SUBJECT: ECCS PERFORMANCE SAFETY ASSESSMENT AND AUDIT REPORT

ECCS Performance Safety Assessment

Audit Report for PWROG and BWROG ECCS Performance Margin Assessment

Figure 3-1: Survey of Calculated Maximum Local Oxidation

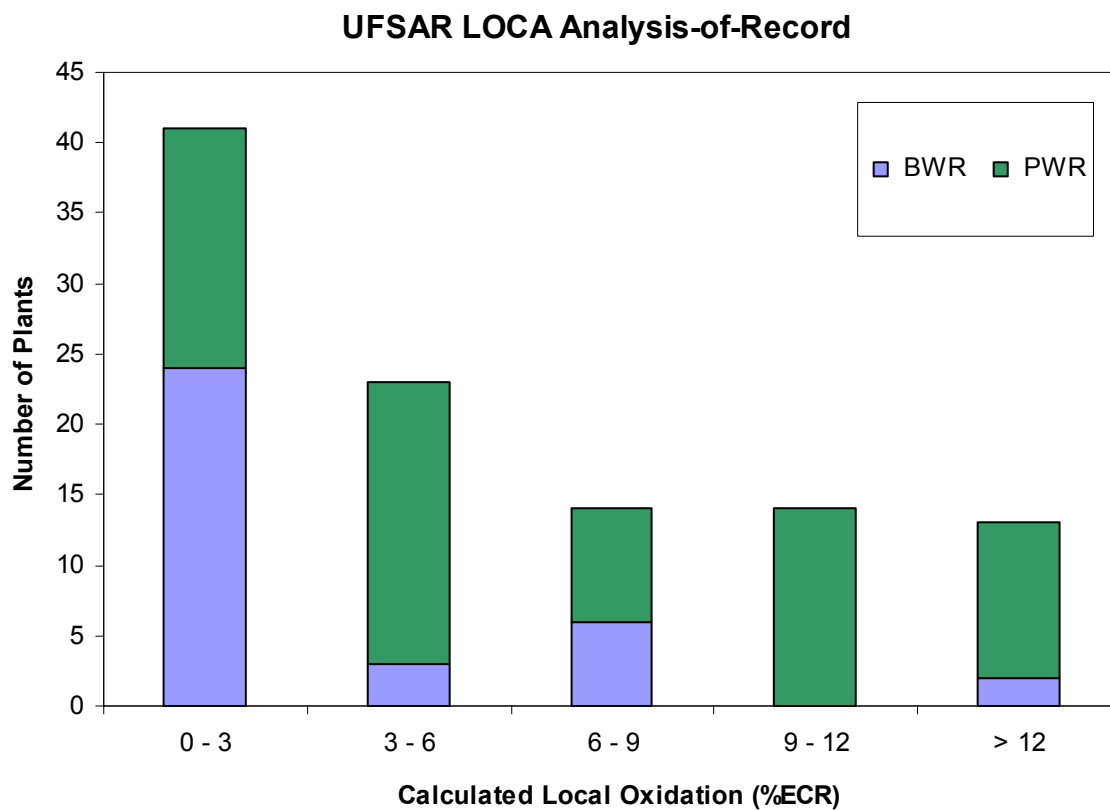
Figure 3-1 illustrates the distribution of calculated ECR from the UFSAR AORs. Note that for PWRs, the maximum calculated ECR between LBLOCA and SBLOCA is shown. Figure 3-2 illustrates the distribution of calculated time above 800°C

Figure 2-2: Allowable CP-ECR versus Pellet Exposure

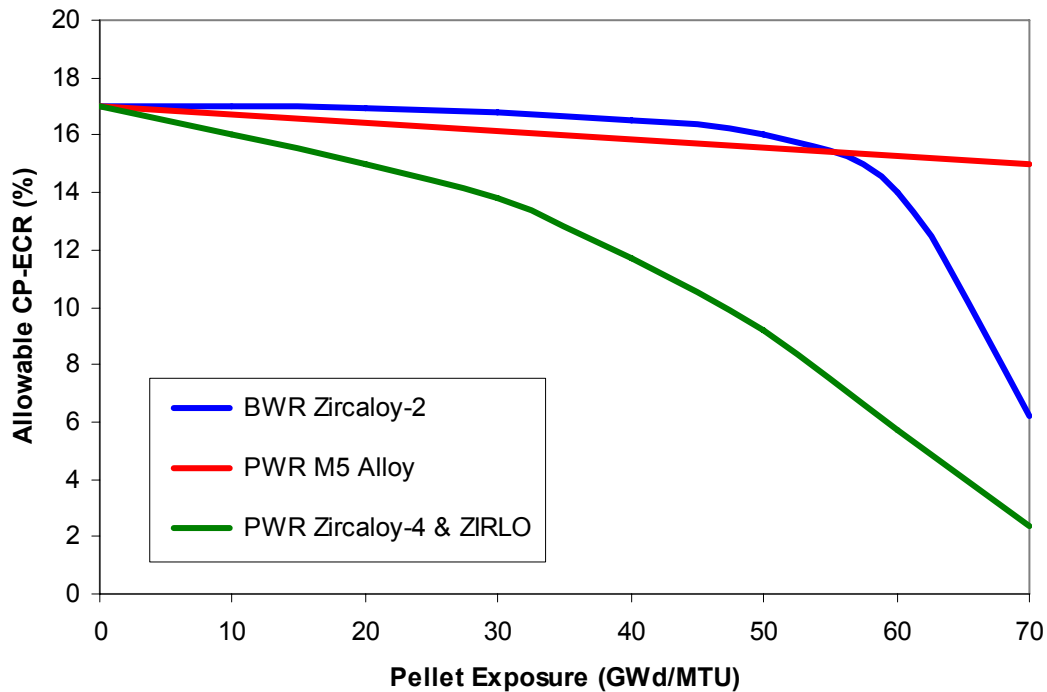
Figure 2-2 illustrates that allowable Cathcart Pawel (CP)-ECR as a function of peak pellet exposure used in the BWROG and PWROG assessments.

Question #8 of the audit plan requested further information on the assumed hydrogen content (and associated allowable CP-ECR) for Group 7. Westinghouse stated that the CE plants comprising Group 7 used conservative Appendix K evaluation models and would have difficulty showing compliance to the bounding ZIRLO analytical limits. As such, new ZIRLO analytical limits were developed using plant-specific fuel duty calculations and the new Westinghouse ZIRLO corrosion model currently under staff review (WCAP-12610-P-A & CENPD-404-P-A, Addendum 2). A hydrogen pickup fraction of 15% was used to convert calculated oxide thickness to cladding hydrogen content (and allowable CP-ECR). This pickup fraction is conservative relative to the 12.5% developed for FRAPCON-3. As a result of these calculations, the Group 7 plants were assessed against a cladding hydrogen content of 267 ppm with an allowable CP-ECR of 10.0%. As stated above, the use of a best-estimate corrosion prediction and hydrogen content is acceptable for this evaluation. However, the staff may require an approved, upper-bound model for future compliance demonstration.

Figure 2-5: Typical BWR COLR Thermal-Mechanical Operating Limits
(Based on ADAMS ML110940268)

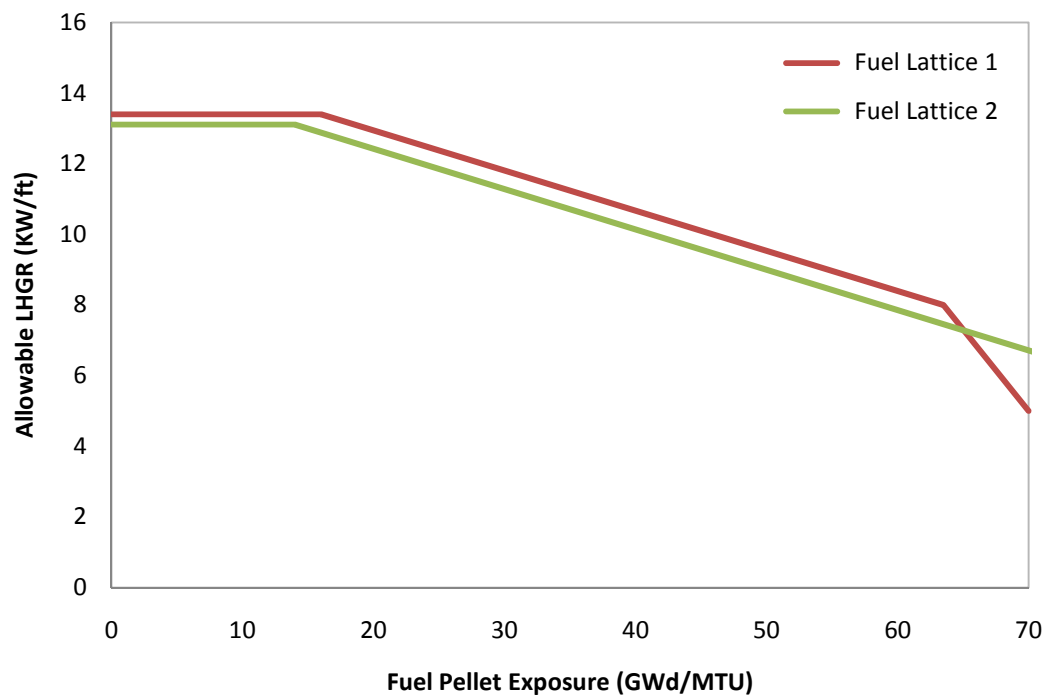
not expected to change on a cycle-specific basis (although their inclusion in the COLR would allow frequent changes). Figure 2-5 illustrates the decrease in allowable peak nodal power with exposure for a typical COLR TMOL.

Figure 2-8: SBLOCA Group 2 Limiting Plant AOR Results
(Source: Westinghouse Proprietary Calculation CN-LIS-11-8)

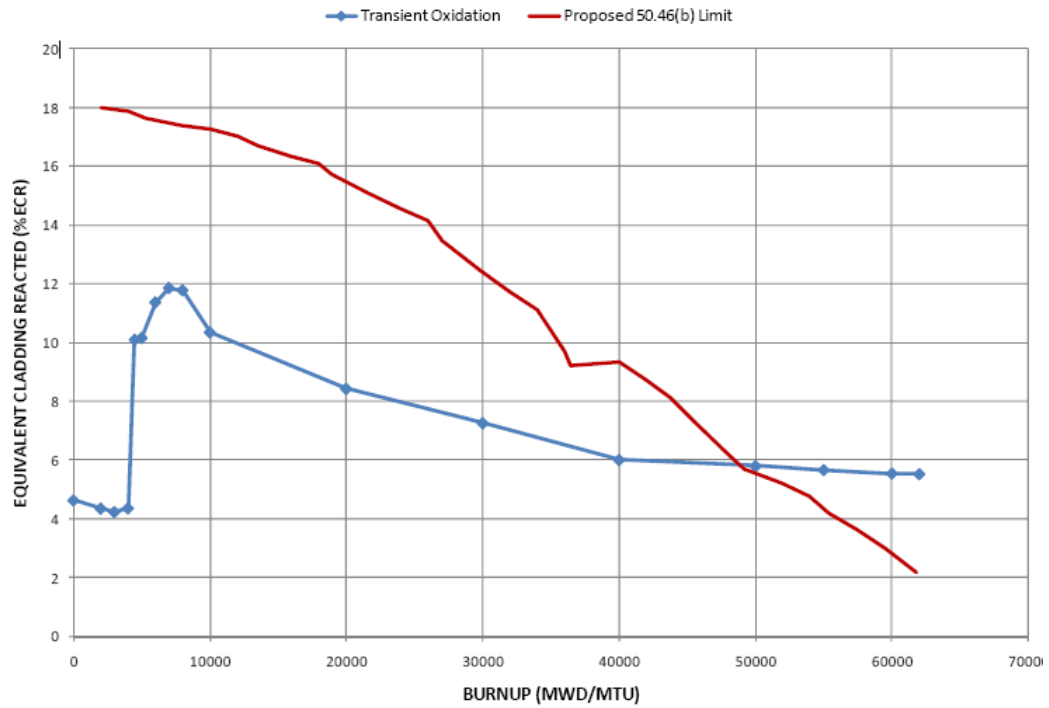
The AOR results, shown in Figure 2-8, illustrate that the calculated MLO exceeds the proposed ECR analytical limits at high exposure. Table 2-1 lists the calculated results for this limiting plant. Examination of this table reveals the significant benefit from switching to the ANS-1979 decay heat plus 2 σ uncertainty on calculated results. In addition to calculations performed for the limiting PCT plant, a separate evaluation was completed for the limiting MLO plant in Group 2. This evaluation confirms the applicability of the calculated credit.
